TM-18-079

Three Mile Island Nuclear Station, Unit 1
Renewed Facility Operating License No. DPR-50
NRC Docket No. 50-289

Subject: License Amendment Request – Proposed Defueled Technical Specifications and Revised License Conditions for Permanently Defueled Condition

Figure 3.1.3-1
 Minimum Burnup Requirements for Fuel in Region II of the Pool A Storage Racks

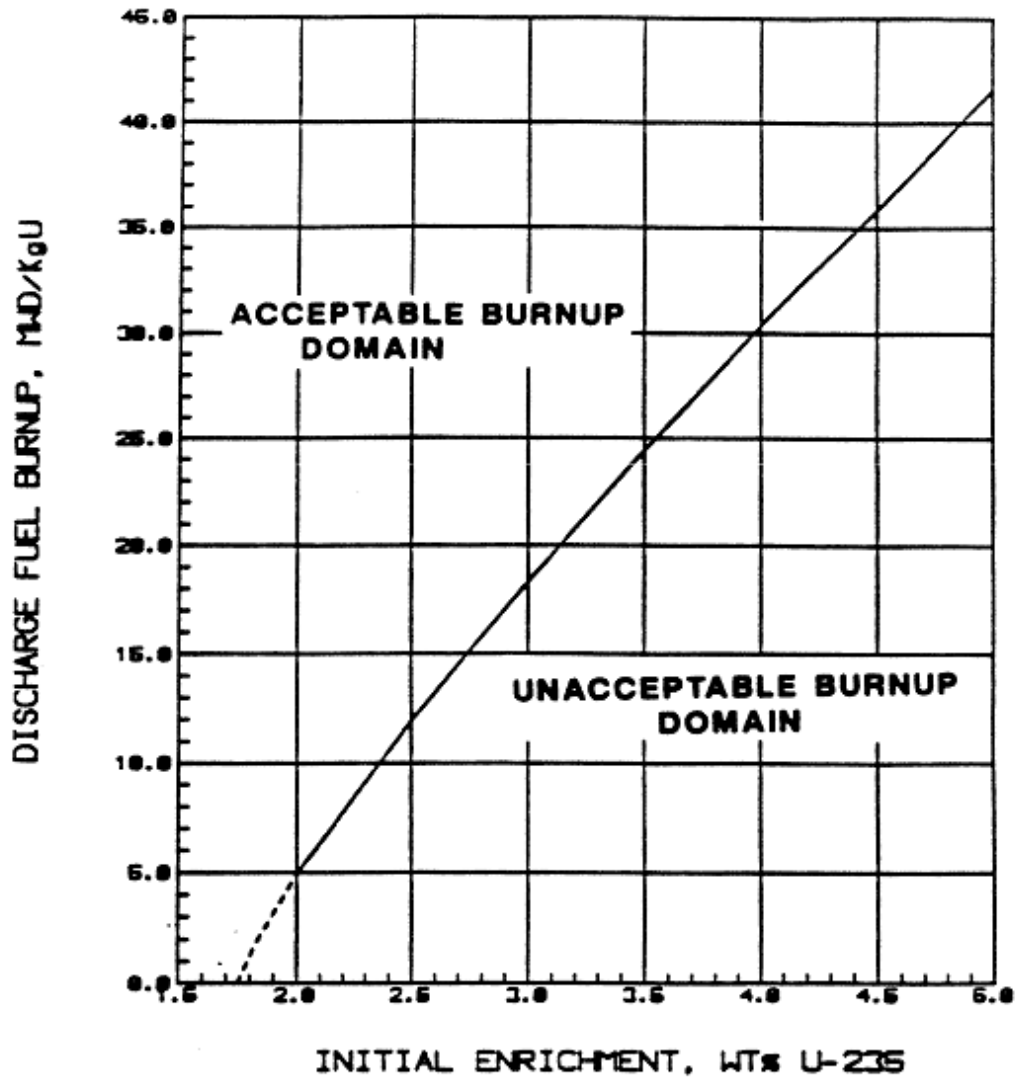
This LCO is proposed to specify the permissible combined initial enrichment and burnup limits of fuel to be Stored in Spent Fuel Pool A Region II and Spent Fuel Pool B. The limits are relocated from TS 5.4 to this new proposed LCO. This specification will have a Surveillance Requirement SR 4.1.3.1 that will verify the loading requirements. This specification satisfies Criterion 2 of 10 CFR 50.36(c)(2)(ii).

TS 5.4.2.g is proposed to be relocated. The specification and Figure 5-4, Minimum Burnup Requirements for Fuel in Region II of the Pool "A" Storage Racks, will be relocated to proposed TS LCO 3/4.1.3, Spent Fuel Assembly Storage.

- 3.1.3.1 The combination of initial enrichment and burnup of each spent fuel assembly stored in Storage Pool A and Storage Pool B, shall be within the acceptable region of Figure 3.1.3-1 or 3.1.3-2.
- 3.1.3.2 When requirement of 3.1.3.1 is not met, immediately initiate action to move the noncomplying fuel assembly to an acceptable configuration.

Figure 3.1.3-2
 Minimum Burnup Requirements for Fuel in the Pool B Storage Racks

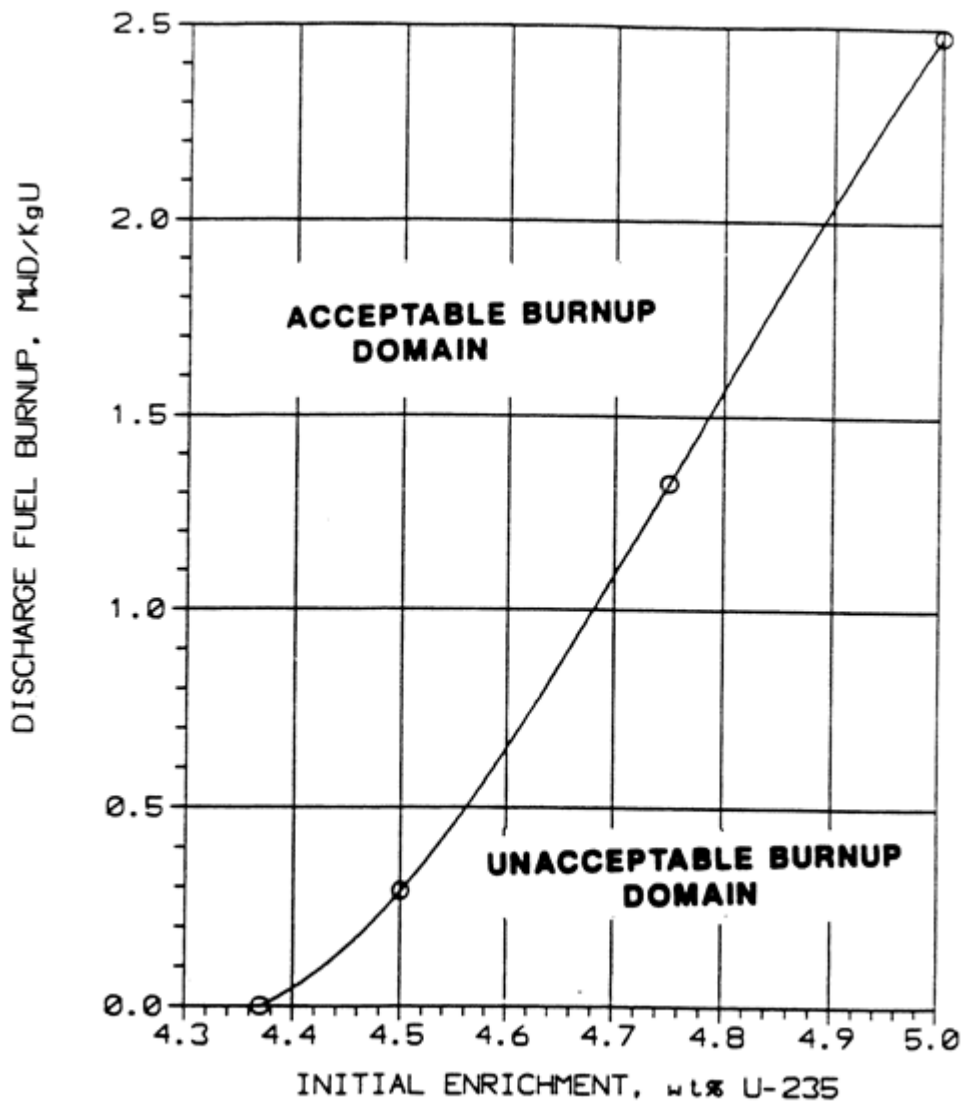
TS 5.4.2.h is proposed to be relocated. The specification and Figure 5-5, Minimum Burnup Requirements for Fuel in the Pool "B" Storage Racks, will be relocated to proposed TS LCO 3/4.1.3, Spent Fuel Assembly Storage.

FIGURE 3.11-1

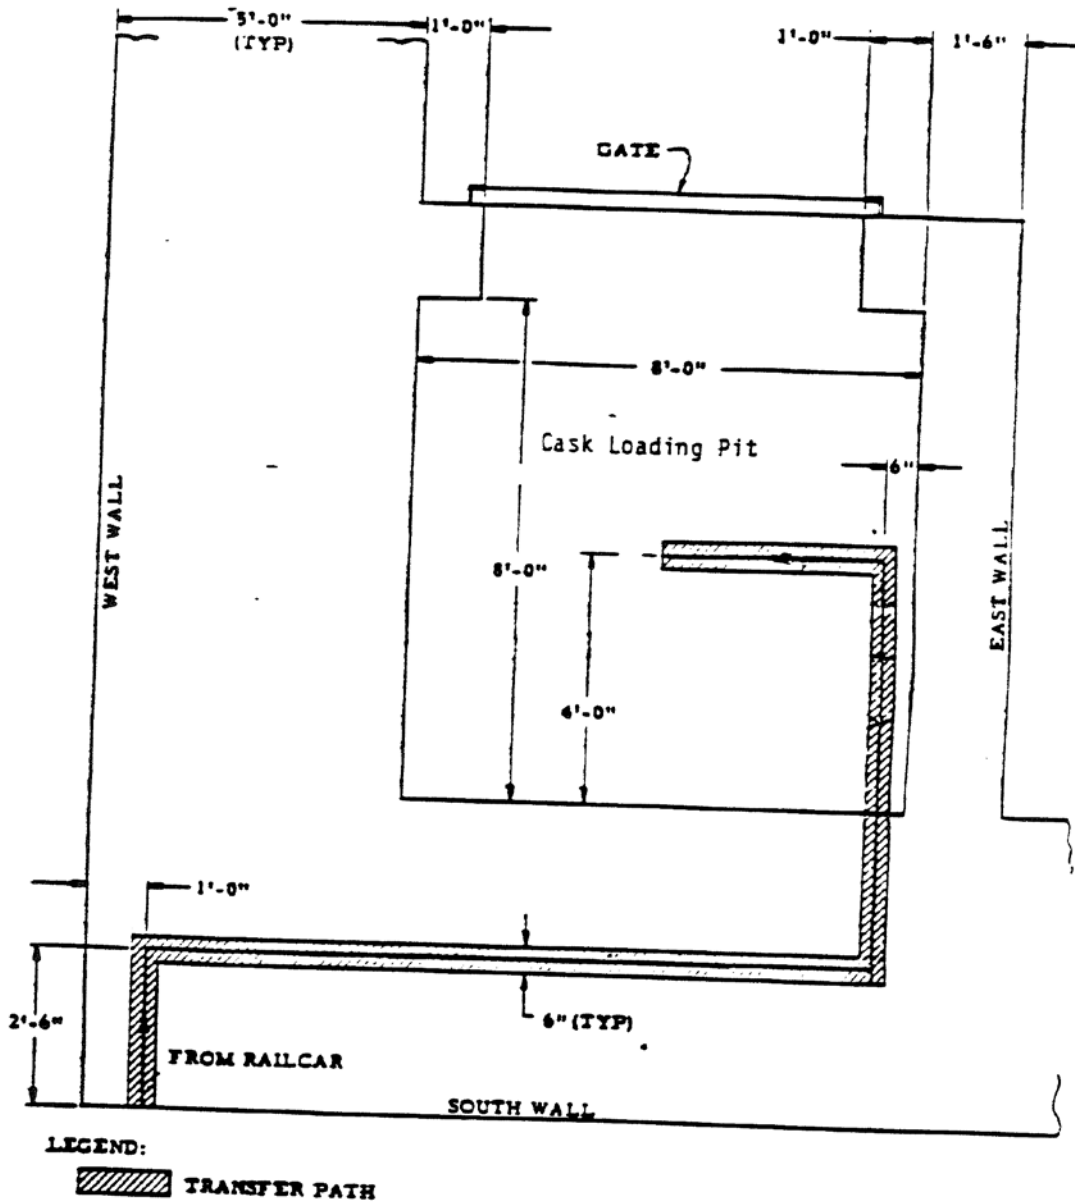
- 3.441.4.7 During transfer of the cask to and from the cask loading pit, the cask will be restricted to the transfer path shown in Figure 3.11-1. Administrative controls will be used to ensure that all lateral movements of the cask are performed at slow bridge and trolley speeds. During this transfer the cask lifting yoke shall be oriented in the East-West direction.
